**Subject:** *Report on the Status of the Nine Mile Point Nuclear Station NPDES/SPDES  
Discharge Permit*

**SUBJECT: Niagara Mohawk Power Corporation (NMPC)  
Nine Mile Point Nuclear Generating Station  
SPDES Permit # NY001015**

**Niagara Mohawk Power Corporation  
Nine Mile Point Generating Station  
SPDES Permit #NY001015  
SPDES Permit Modification Requests**

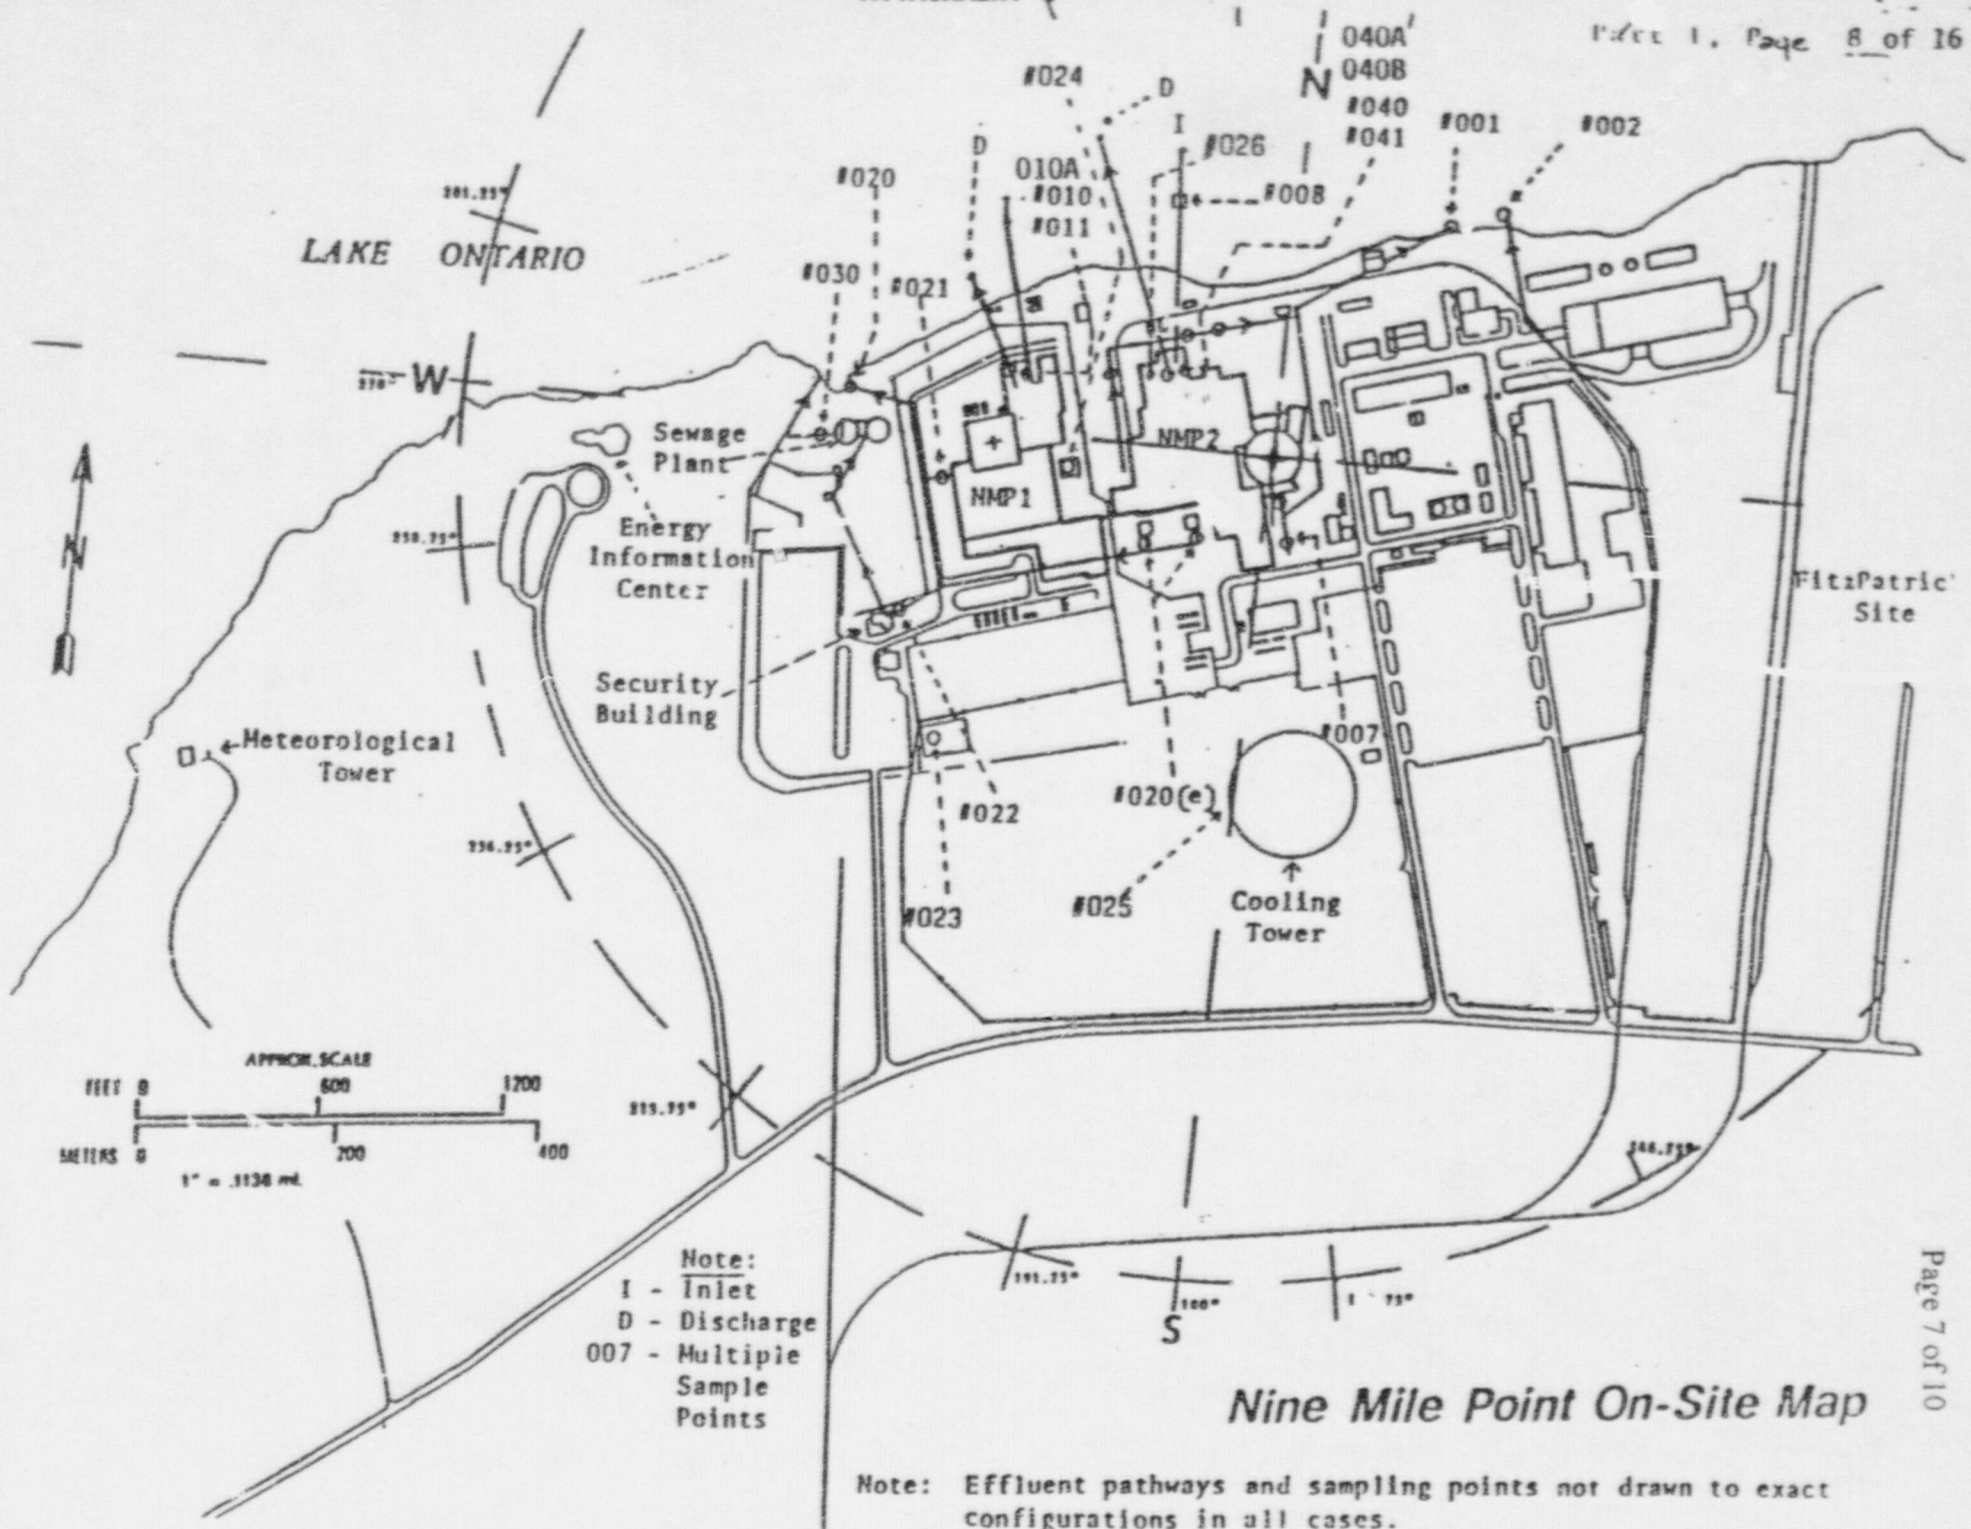
3. For Units 1 and 2, the forebay cleaning is necessary to remove zebra mussels and settleable solids from these structures to assure the necessary flows for cooling. It is NMPC's intent to construct settling basins outside the screen house for the respective facilities to allow for the settling out of solids from future cleaning evolutions. It is requested that the discharge limits for these new outfalls, Outfalls 010A, Unit 1 Forebay Cleaning Basin and 040A, Unit 2 Forebay Cleaning Basin have daily average limit of 50 mg/liter for total suspended solids and a daily maximum of 100 mg/liter. It is requested

frequency be two samples per month, that they be grab samples from these newly created outfalls and that they only be sampled during the cleaning evolution of the forebays.

Outfall 010A will discharge to Outfall 020 and Outfall 040A will discharge to Outfall 001.

**ATTACHMENT 2**  
**Nine Mile Point Nuclear Station**  
**Niagara Mohawk Power Corporation**  
**Permit # NY 000 1015**  
**Lake Ontario**

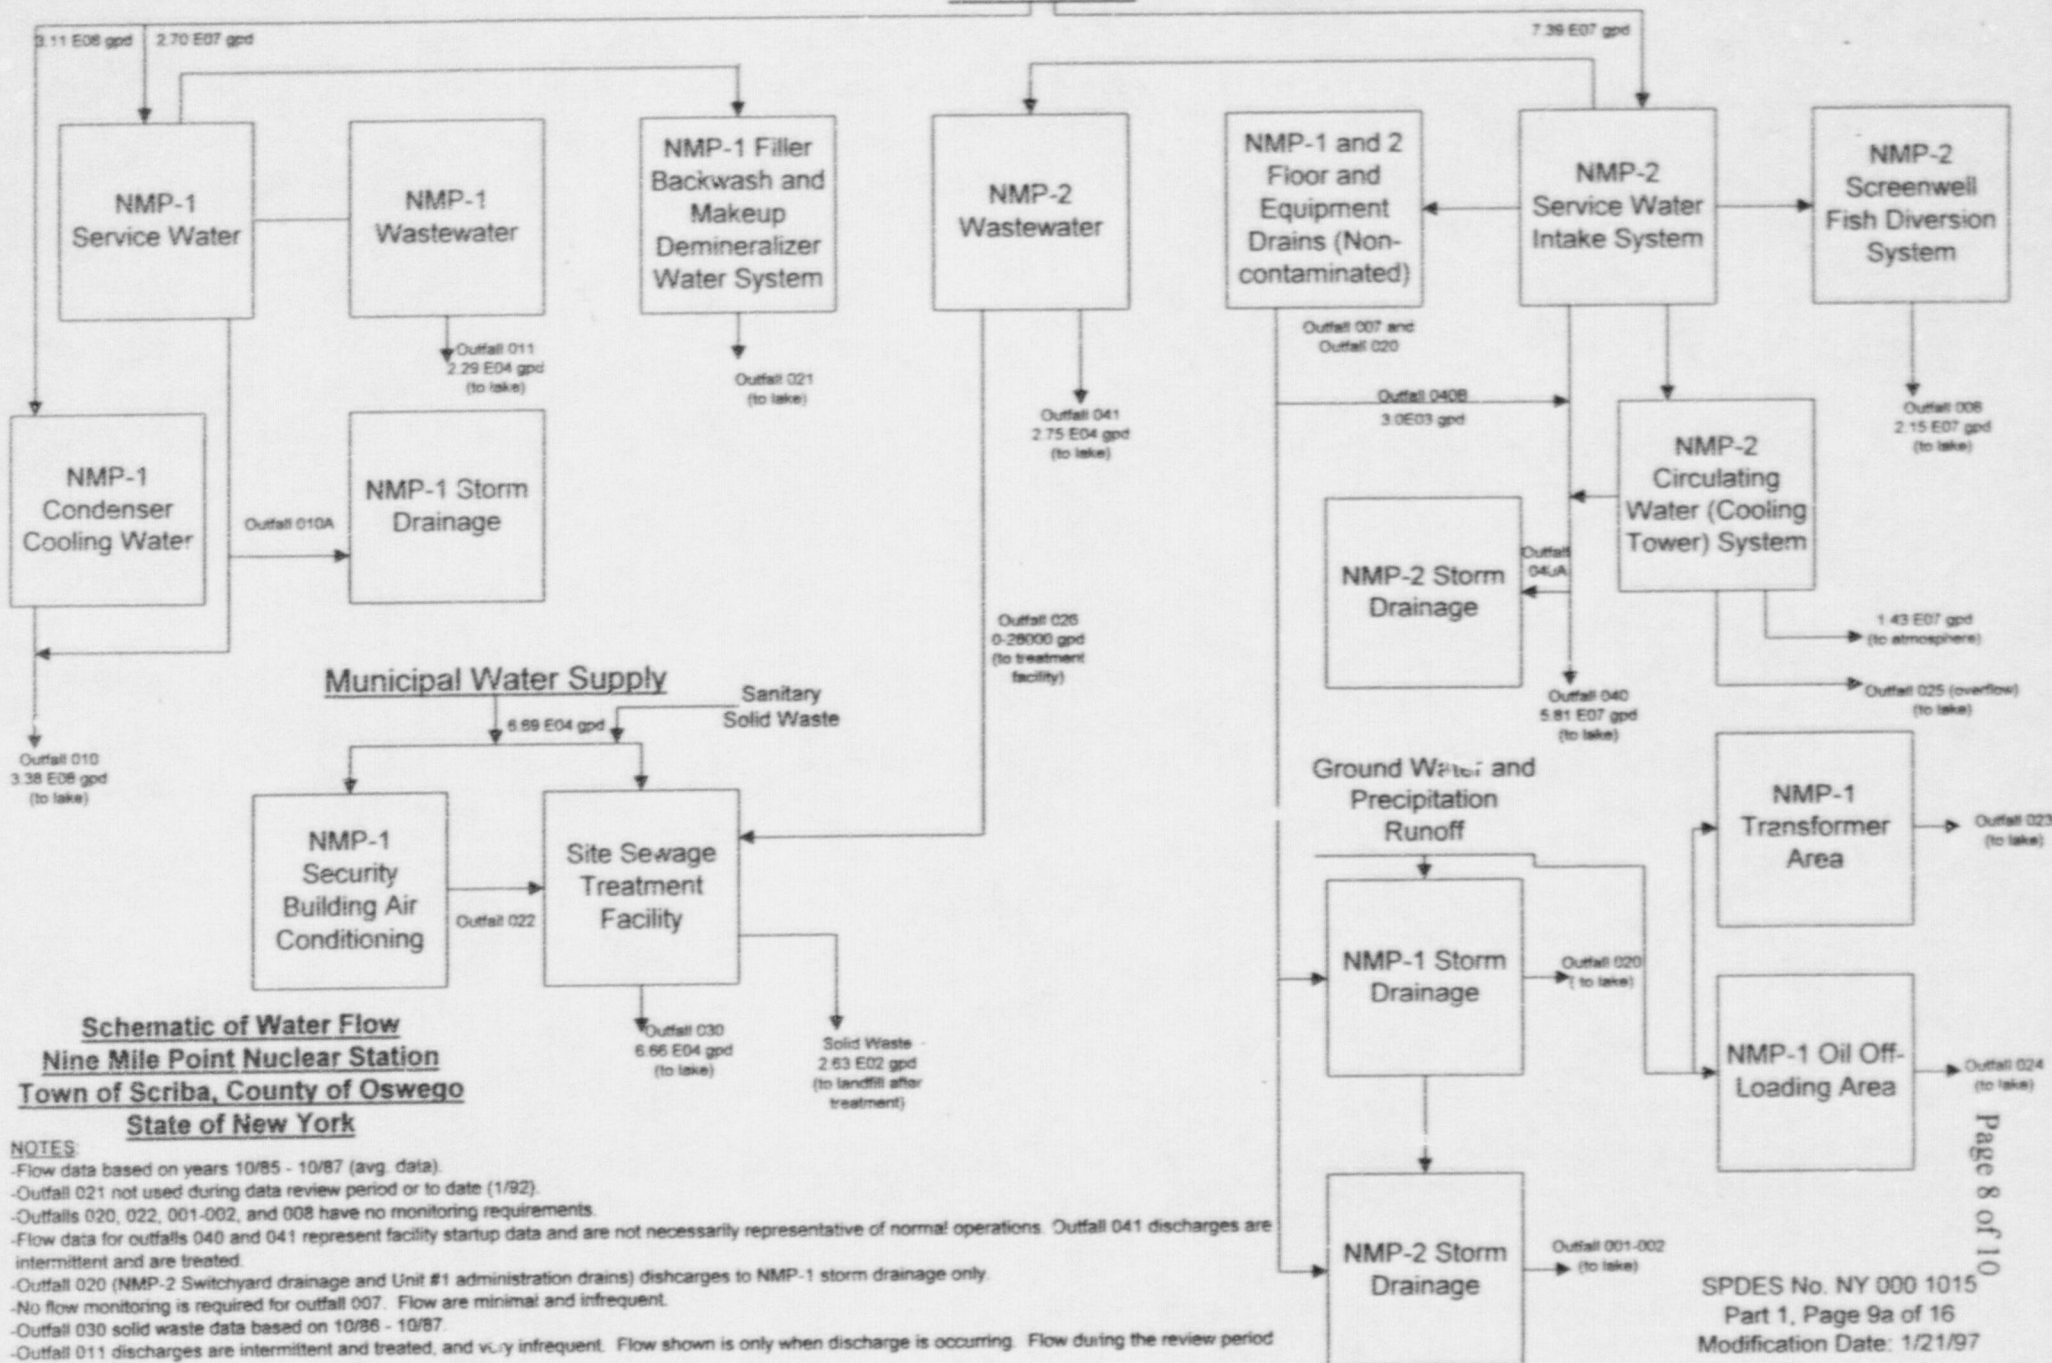
11. Attached is a newly modified Nine Mile Point On-Site Map, page 8 of 16, and Schematic of Water Flow, page 9a of 16, that reflect the additions of Outfalls 010A, 040A and 040B, (Attachment 1 and 2).
